Product Change Notification / MFOL-22JIOK836

CCB 6065 Initial Notice: Qualification of MTAI as an additional assembly site for PD69208T4ILQ-TR-LE, PD81101ILQ-TR-LE, PD69208MILQ-TR-LE, PD69204T4ILQ-TR-LE, and PD39208ILQ-TR-LE catalog part numbers (CPN) available in 56L VQFN (8x8x1.0mm) package.

NSEB

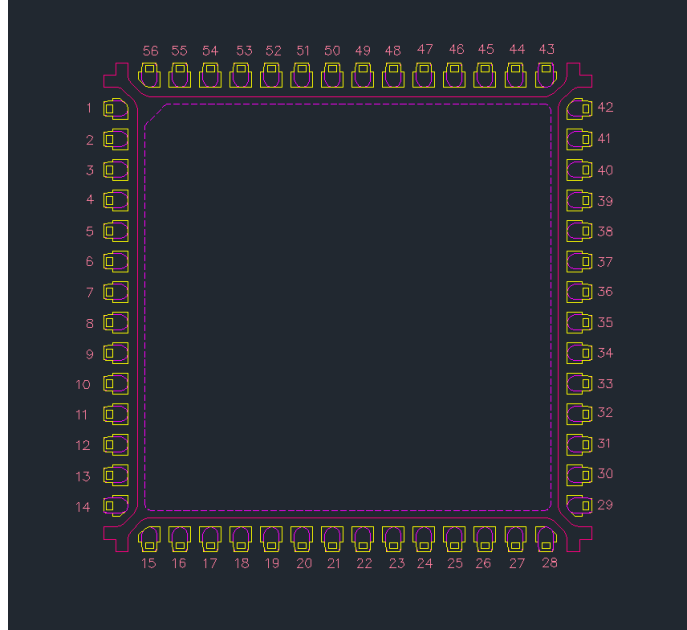
Pre and Post Summary – Bondshell Comparison

Leadframe Material

C194

Note: * C194, A194 or CDA194 Lead frame material are the same, it is just a MCHP internal labelling difference.

MTAI

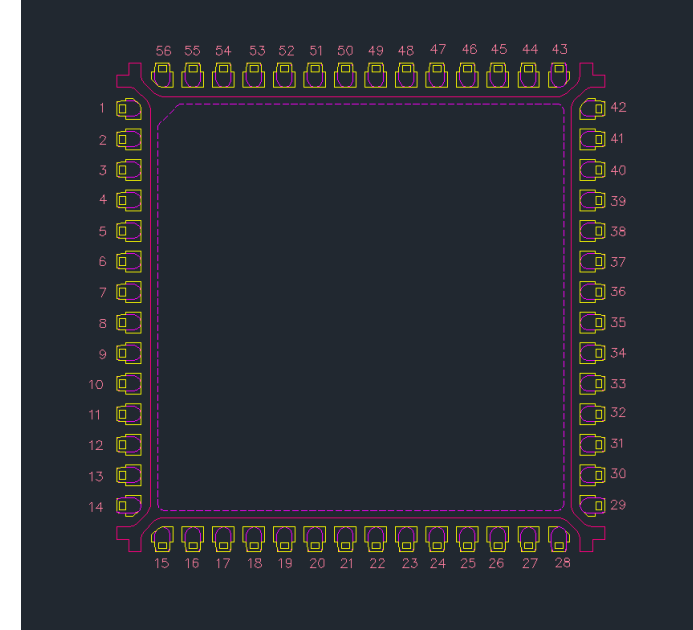
Leadframe Material

A194
